TARA ESTATES SEWER
PUMP STATION UPGRADE

City of Rochester: Bid 23-01
CWSRF Project Number: CS-330122-19

ADDENDUM NO. 2

Drawing Title:
**PARKING LOTS AND
 DRIVEWAYS DETAIL**

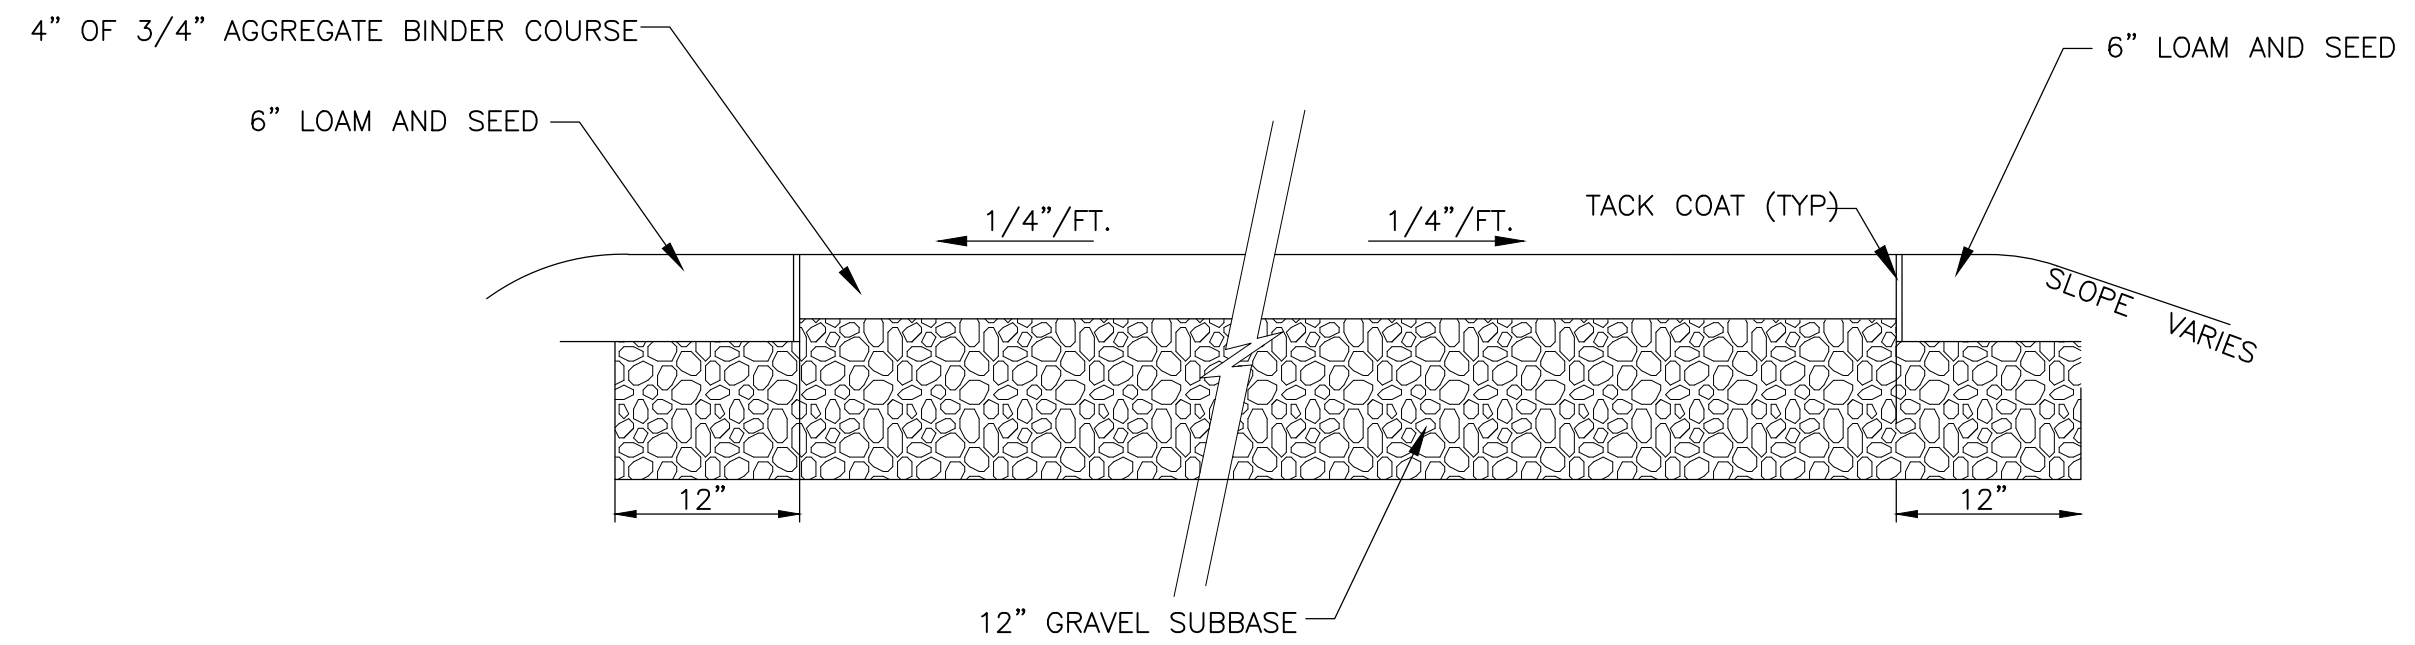
Replace the “PARKING LOTS AND DRIVEWAYS” detail on Sheet C501 with the attached detail.

Question: The specs call for 5.5” of pavement and the plans detail 3.5”. Can you clarify the correct section please?

Answer: The specification and pavement detail should both read 4” of ¾” winter binder, with no top course.
